ONSITE SEWAGE DISPOSAL SYSTEM

PROPERTY ADDRESS: 4811 River Crossing Court

SUBDIVISION: Homewood Crossing LOT: 72 TAX ID: _____

PLOT PLAN FOR BAT INSTALLATION
LOT 72
HOMEWOOD CROSSING
LIBER 9808, FOLIO 204
PLAT No. 18243
TAX No. 05-443377
FIFTH ELECTION DISTRICT
HOWARD COUNTY, MARYLAND
ADDRESS: 4811 RIVERCROSSING COURT
ELLCOTT CITY, MARYLAND

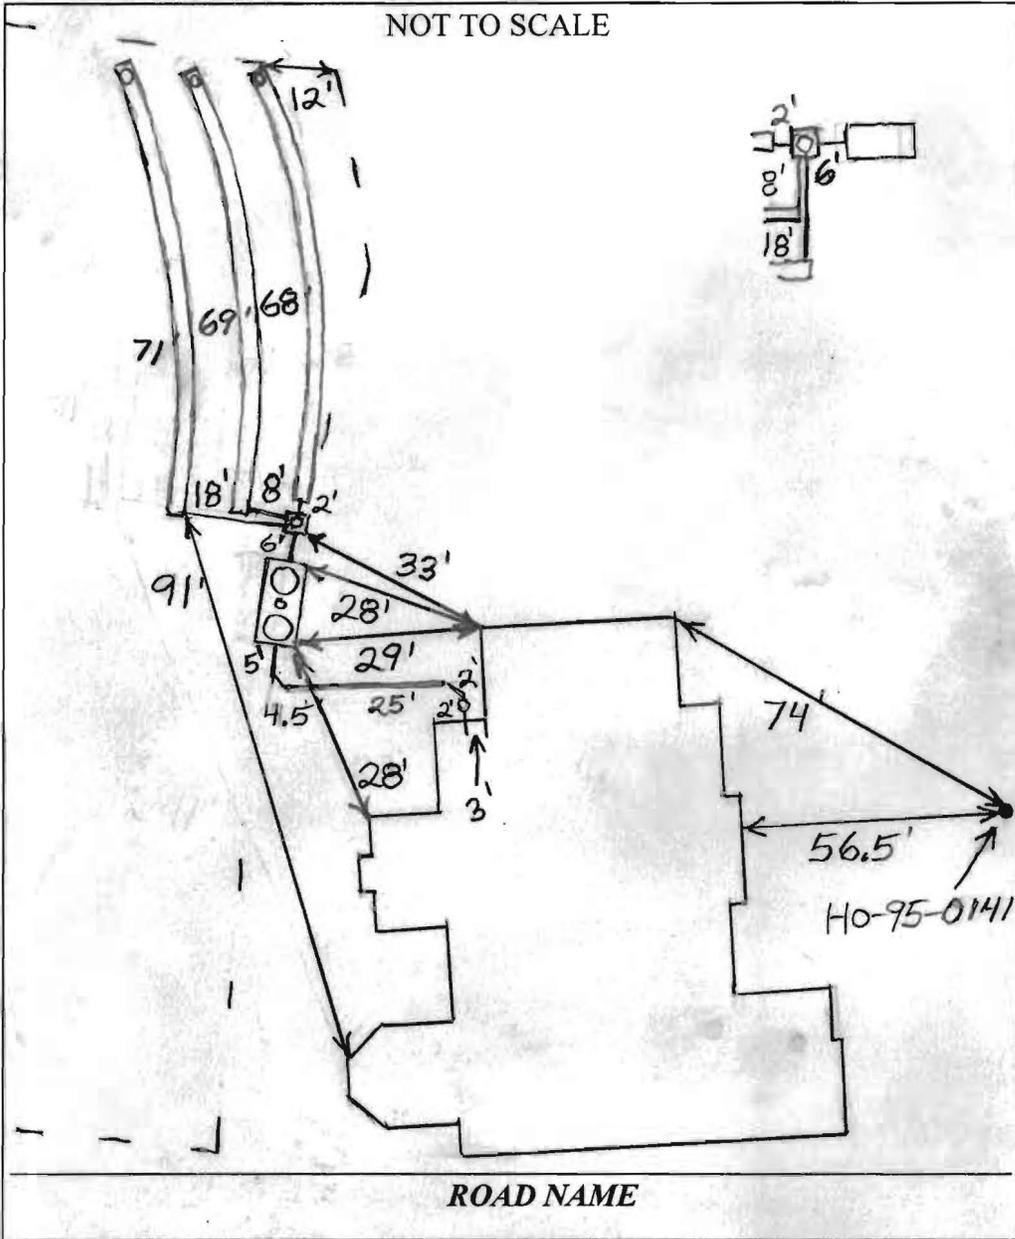
9/18/2014 Plumbing coming out of house in wrong location. Place the dist. box close to the top center of the easement. Install three 70' trenches on contour towards lot 73. O.K. to put the tank just inside the easement in front of the dist. box. Keep the tank shallow so that the entire easement can be used for repairs. (BB)

9/15/2014 Tank set. Finishing up bottom trench. O.K. to backfill when done. To make house connection tomorrow after scaffolding is moved (BB) 9/16/2014 House connection made. Need BAT approval memo. from Babylon (BB)

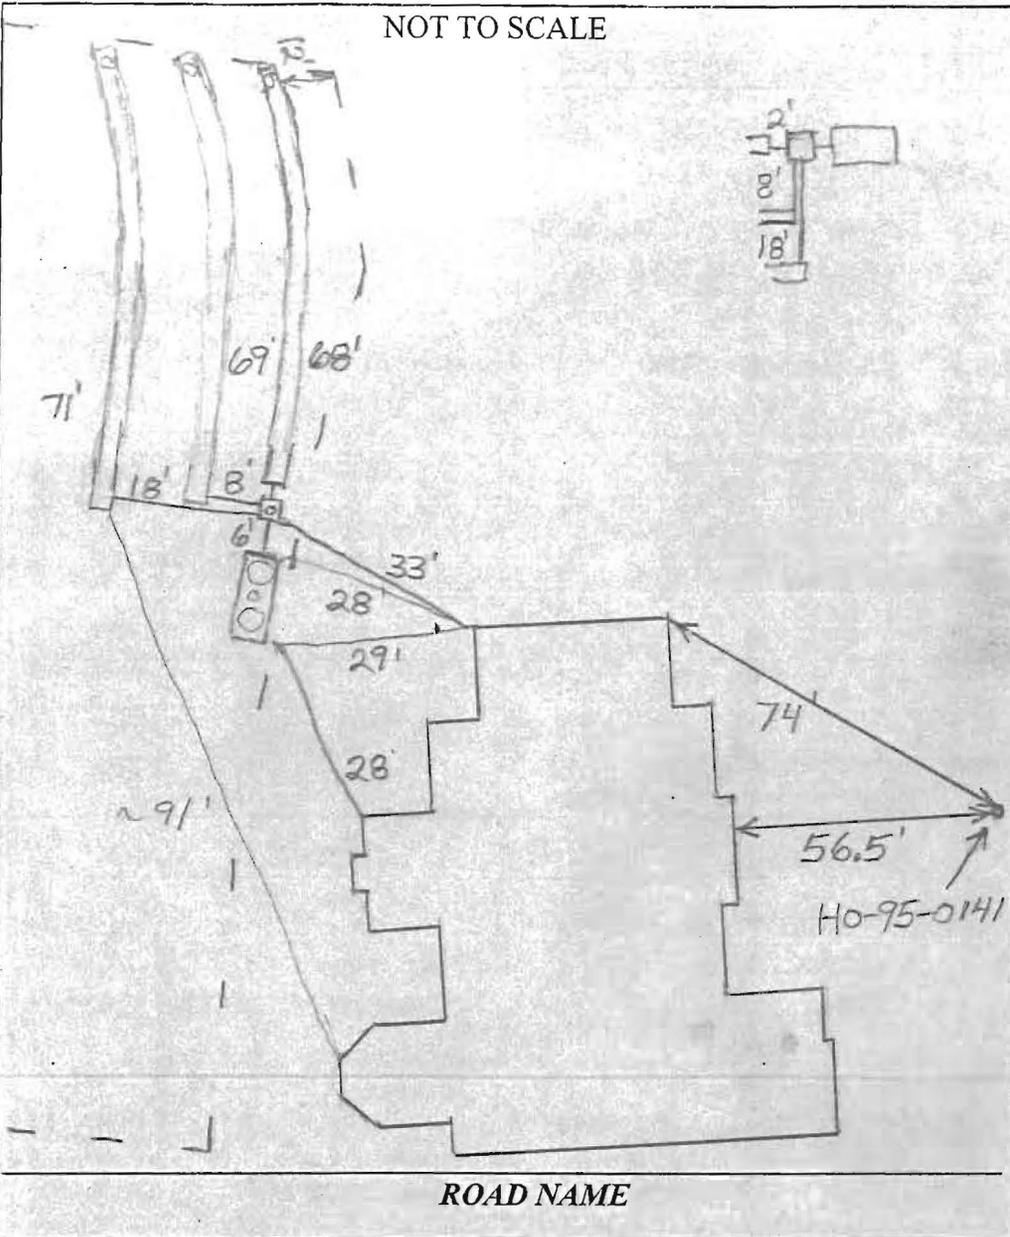
9/13/2014 Plumbing coming out of house in wrong location. Place the dist. box close to the top center of the easement. I install three 70' trenches on contour towards lot 73. O.K. to put the tank just inside the easement in front of the dist. box. Keep the tank shallow so that the entire easement can be used for repairs. (B)

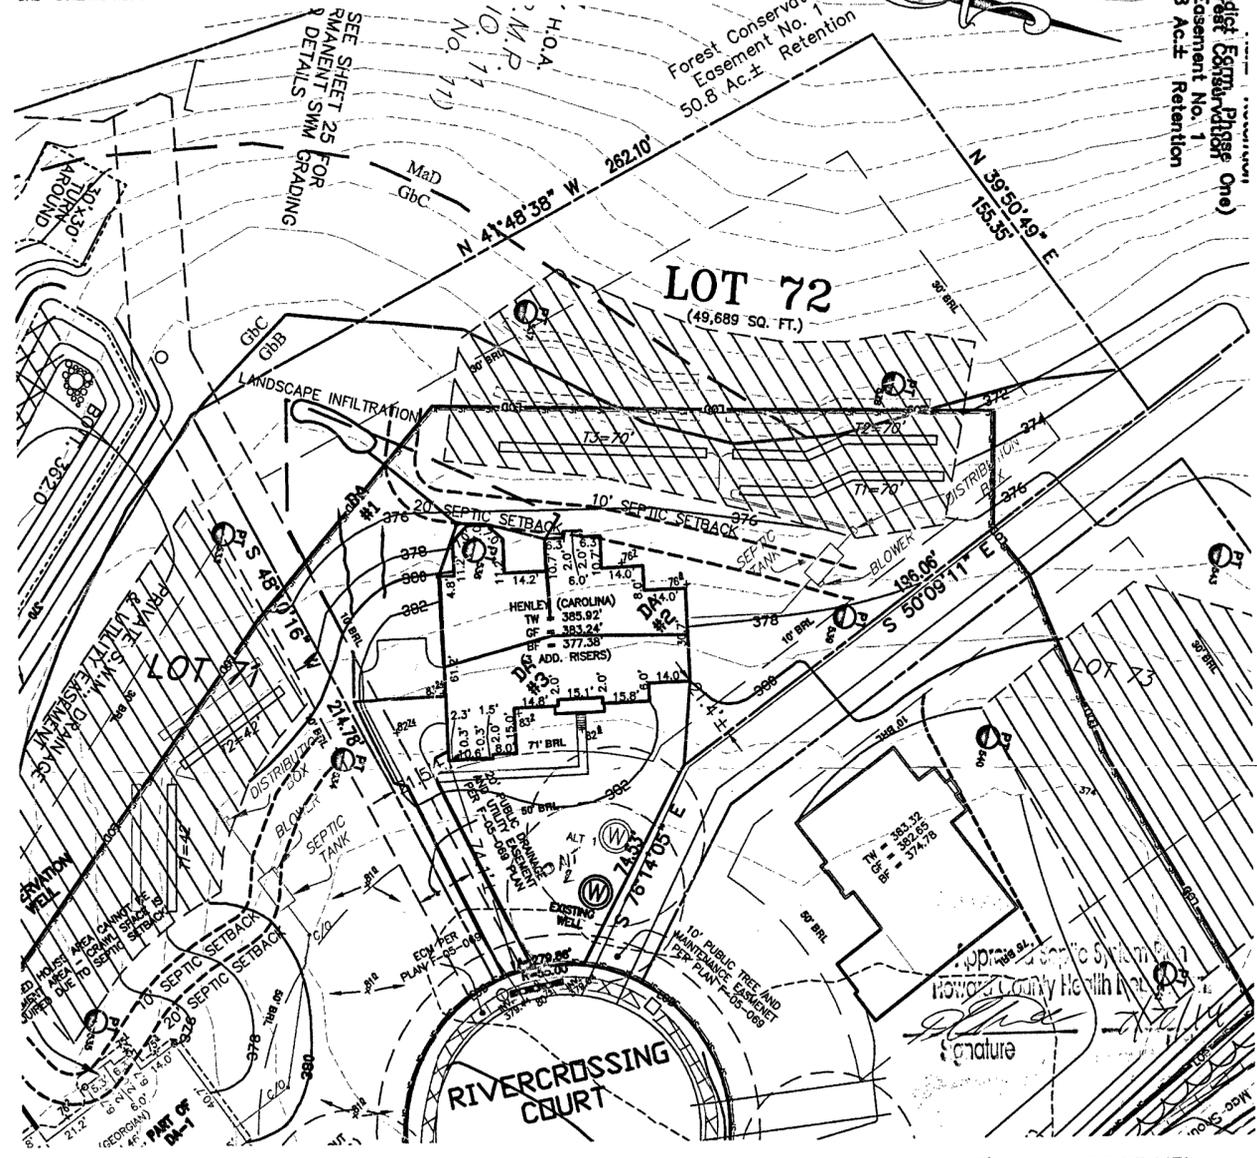
Looking at the file, I do not see an abandonment report for well HO-95-0141. We have the completion report for the new well, 95-2504. In order to move forward with the building permit, we will need the abandonment report, and then we will need a revised BAT plan showing the new well location and alternate well locations as well as all of our standard requirements for the septic system design. In the meantime, if you could also send us a pdf of the floorplans for the proposed house, we could make sure the number of bedrooms matches the septic sizing when we get the BAT plan for review. Thanks
